Form 3160-5
(June 2019)UNITED STATES
DEPARTMENT OF THE INTERIOR
BUREAU OF LAND MANAGEMENTFORM APPROVED
OMB No. 1004-0137
Expires: October 31, 2021**SUNDRY NOTICES AND REPORTS ON WELLS**
Do not use this form for proposals to drill or to re-enter an abandoned well. Use Form 3160-3 (APD) for such proposals.

8. Well Name and No. ROSS DRAW 17 FED COM/714H

EOG respectfully requests an amendment to our approved APD for this well to reflect the following changes:

Revised Wellbore

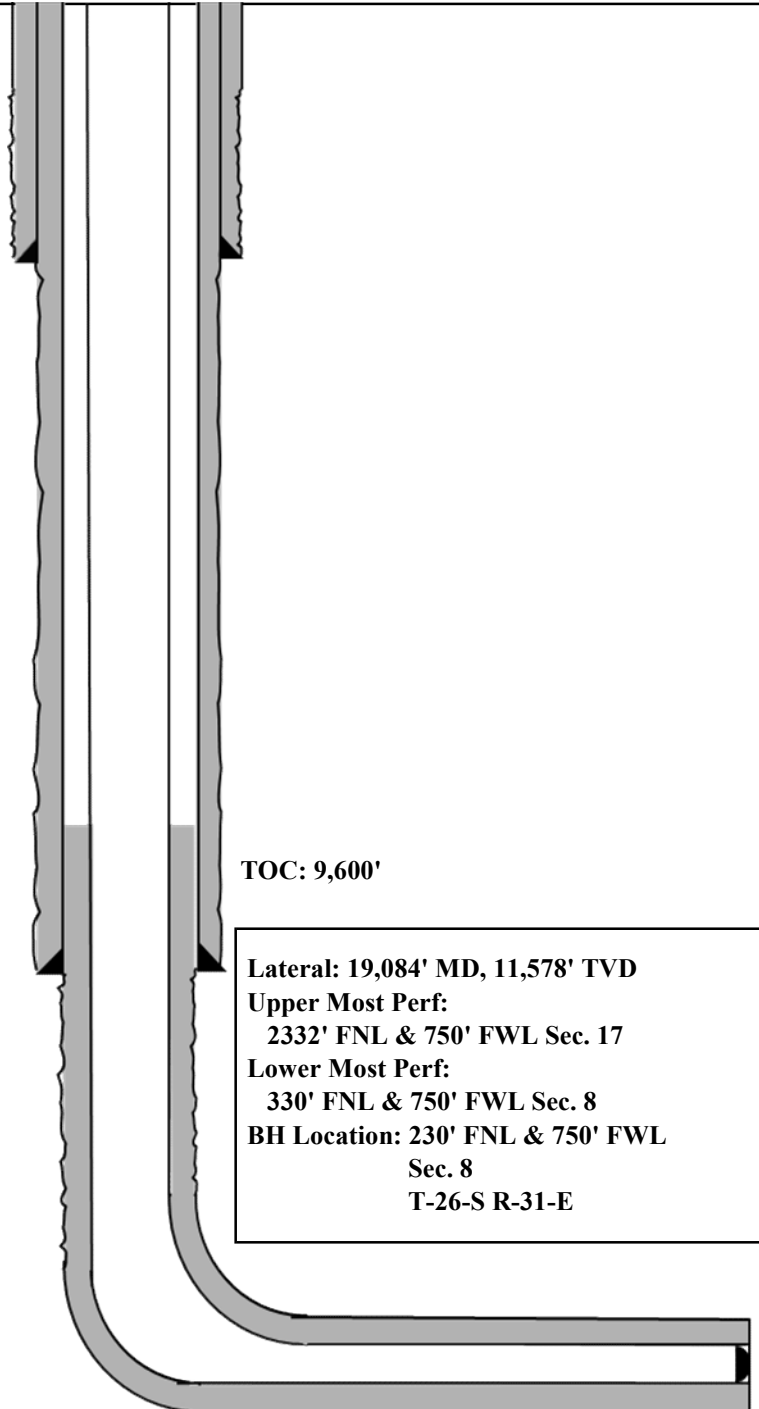
Change BHL from T-26-S, R-31-E, Sec 8, 230' FNL, 660' FWL, Eddy Co., NM,
to T-26-S, R-31-E, Sec 8, 230' FNL, 750' FWL, Eddy Co., N.M.
Update casing and cement program to current design.

Bit Size: 8-3/4"
7-5/8", 29.7#, HCP-110, FXL,
@ 0' - 10,100'

Bit Size: 6-3/4"
5-1/2", 20#, P110-EC, DWC/C IS MS,
@ 0' - 9,600'

5-1/2", 20#, P110-EC, Vam Sprint SF,
@ 9,600' - 10,100'

5-1/2", 20#, P110-EC, DWC/C IS MS,
@ 10,100' - 19,084'

KOP: 11,104' MD, 11,100' TVD
EOC: 11,854' MD, 11,578' TVD
